**Re: Contract No. HY/2010/08
Central – Wan Chai Bypass – Tunnel (Slip Road 8 Section)
Additional Mitigation Plan for Slip Road 8 (Rev. 4)**

Additional Mitigation Plan for Slip Road 8 (Revision 4)

Additional Mitigation Plan for Slip Road 8 under condition 2.16 of FEP- 10/364/2009/B

Revision: 4

SECTION A-A
SCALE A3 1:100
soil depth varies from 1.7m to 4.5m for bamboo planting

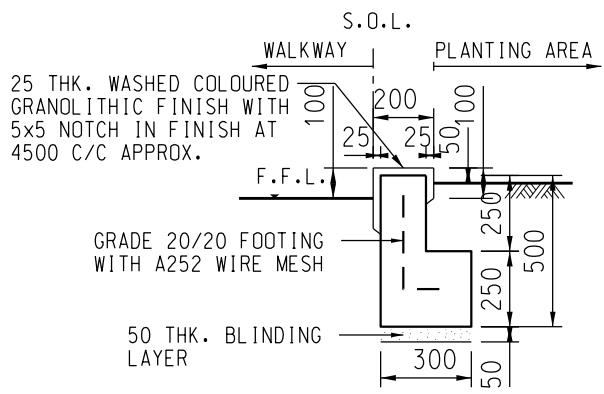
<ul style="list-style-type: none"> • Details to support the proposed bamboo planting, e.g. width and depth of soil medium and irrigation arrangement should be indicated in the section A-A drawing. 	For the width of the soil medium please refer to the site sketch as attached in Appendix C . For the depth of the soil medium, it varies from 1.7m to 4.5m. For the irrigation arrangement layout and details of waterpoint, please refer to the site sketch as attached in Appendix E .

WALL PATTERN DETAIL FOR NOISE SCREENING
 SCALE A1 1 : 25
 A3 1 : 50

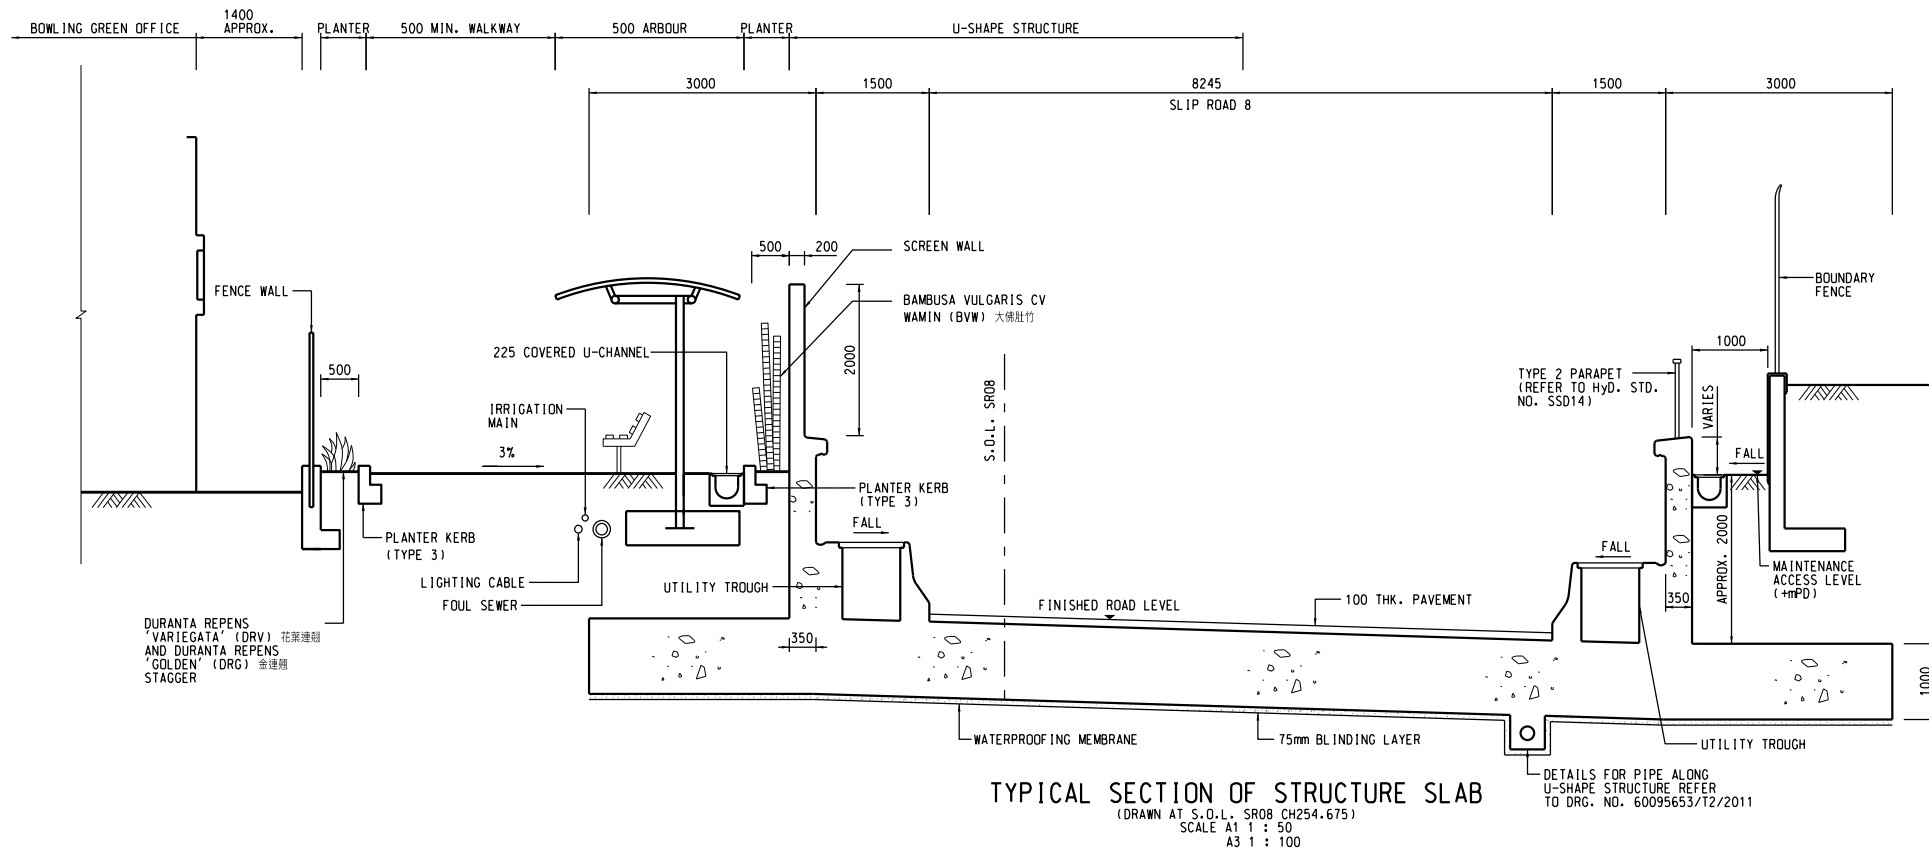
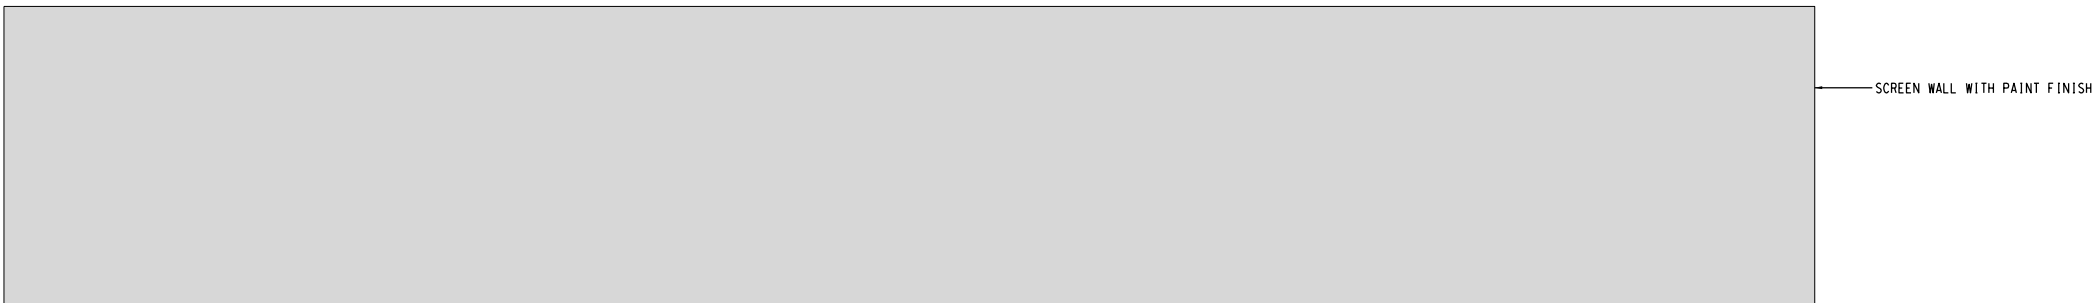
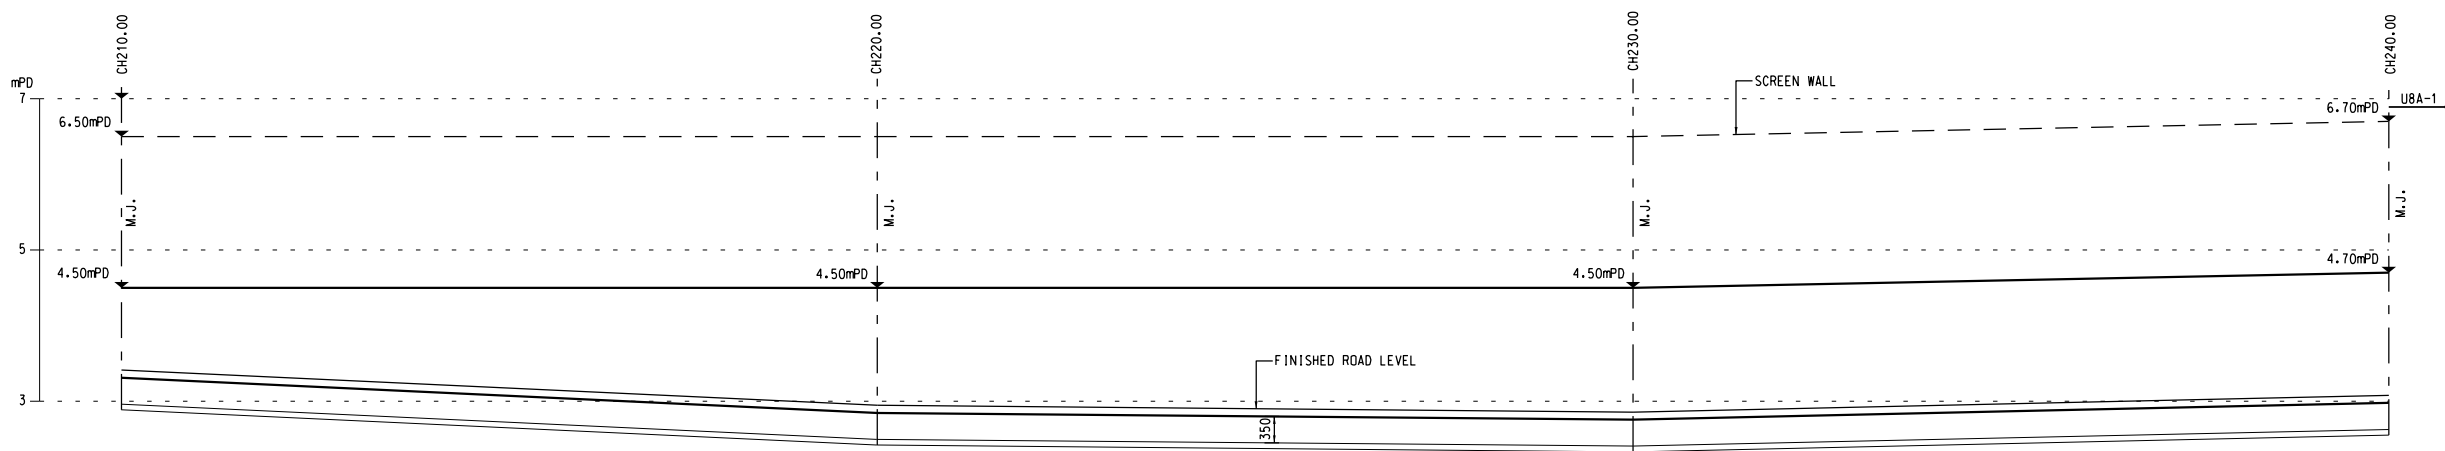
Further to the noise screening structure proposed under the Additional Mitigation Plan (Rev.02) approved on 09-04-2015, Noise Screening Structure will be constructed without the wall pattern, a Planter Kerb will be constructed in front of the screen wall and *Bambusa Vulgaris* cv. Wamin (BVW) will be planted. (Please refers to Appendix B for the proposed planting plan and Appendix C for details on noise screening structure).

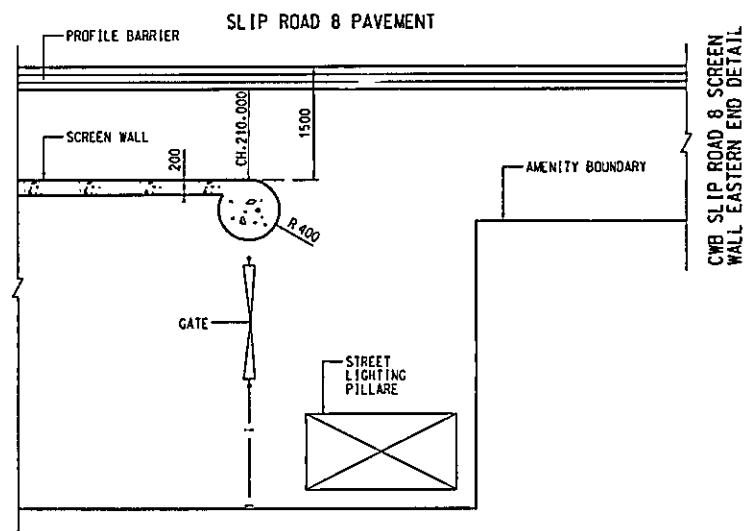
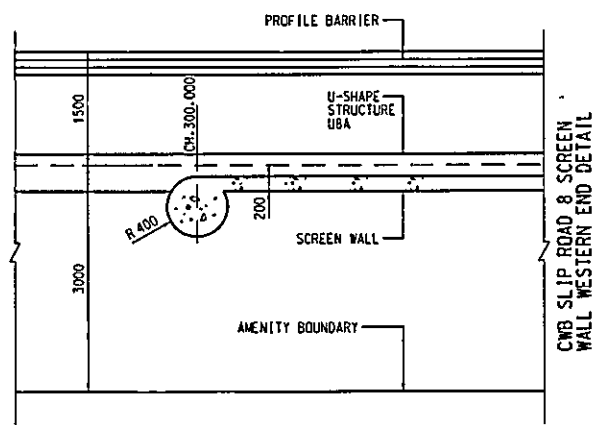
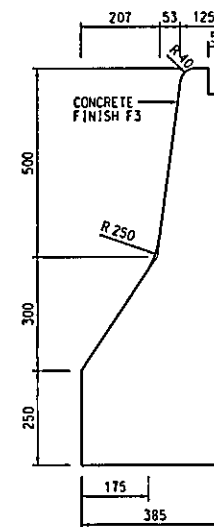
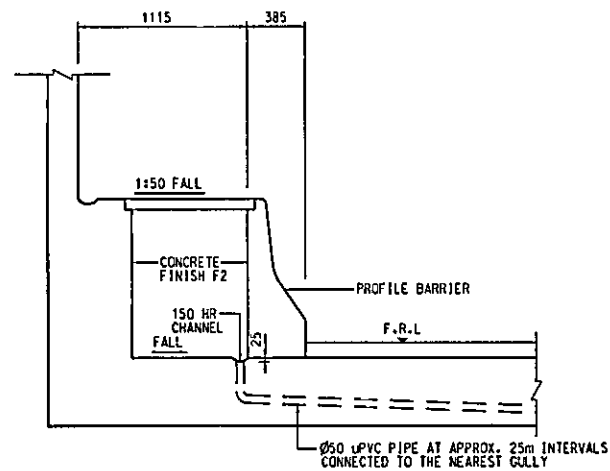
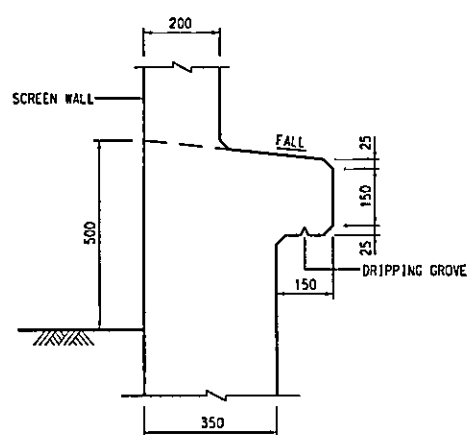
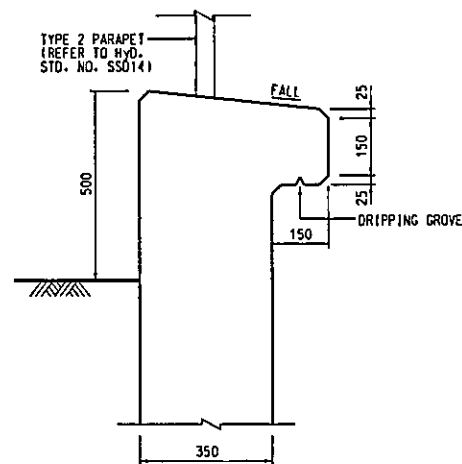
Deletion of Wall Pattern on Screen Wall

In accordance with GCC Clause 6(3), i enclose Sketch No. 60095653/T2/SK0760 showing the deletion of the wall pattern on the Screen Wall.

TITLE:
 LAYOUT FOR ELDERLY FITNESS AREA
 IN VICTORIA PARK

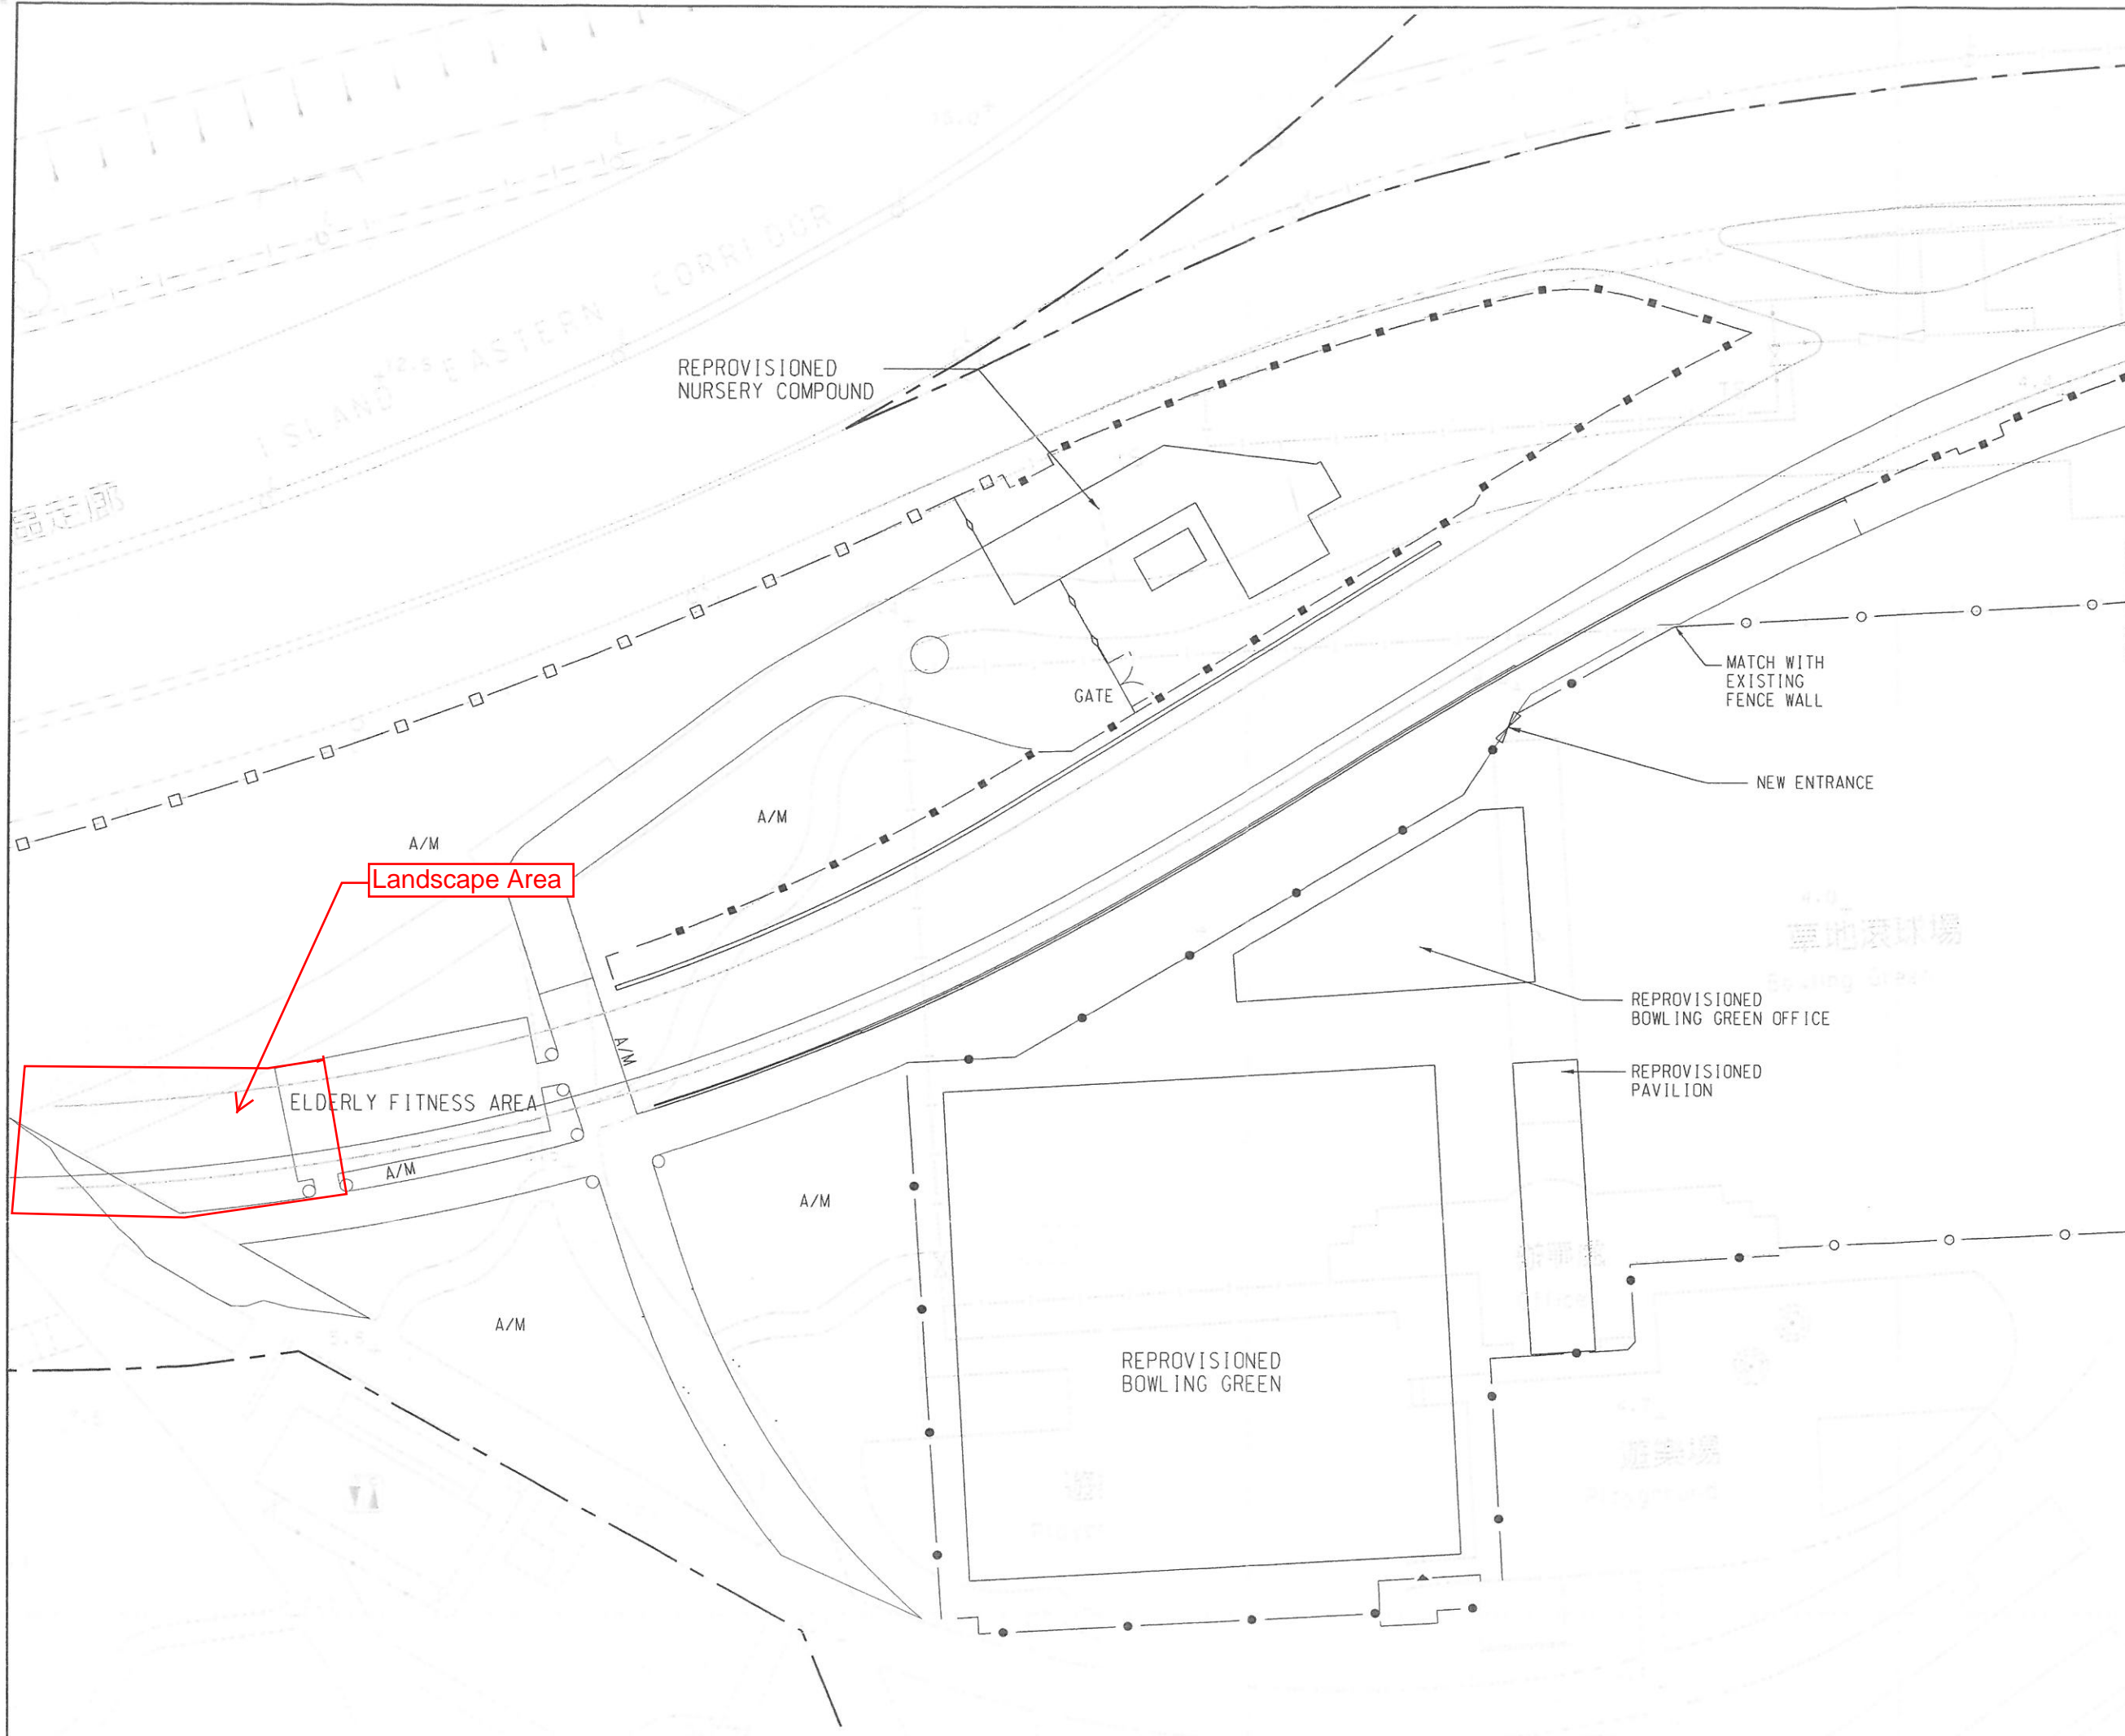
2. For Appendix D – ‘Part of the landscape area above Slip Road 8 occupied by additional elderly fitness facilities’:	
<ul style="list-style-type: none"> • Provided that the original proposed shrub and/or tree planting in this landscape area will not be affected, we have no comment on the above proposal. 	Noted
<ul style="list-style-type: none"> • The EP holder is reminded to seek comment from the future maintenance agent regarding the additional elderly fitness facilities, in particular the horizontal clearance requirements. 	The acceptance from VPMO regarding the additional elderly fitness facilities have been obtained on 22 October 2018, please refer to Appendix D .
<ul style="list-style-type: none"> • Noting that the location of proposed additional elderly fitness facilities is adjacent to the Slip Road 8, dense screen planting should be considered to protect users from the air pollution sources. 	Please note that the proposed elderly fitness facilities was located on top of Slip Road 8 and away from tunnel portal. With the structure of screen wall along tunnel portal and planting area surrounding the elderly fitness facilities, the user would be protected from the air pollution source.

Contract No. HY/2010/08
Central-Wan Chai Bypass – Tunnel (Slip Road 8 Section)**Variation Order No. V/039**
Additional Elderly Fitness Facilities within Victoria Park

1. Supply similar to the attached photographs and install three sets (maximum) elderly fitness equipment as discussed and recorded in Victoria Park Working Group Meeting No. 47 in the "Elderly Fitness Area" as shown on the attached Sketch No. 60095653/T2/SK0720. The exact details and location of the elderly fitness equipment shall be confirmed and agreed on site with the ER.
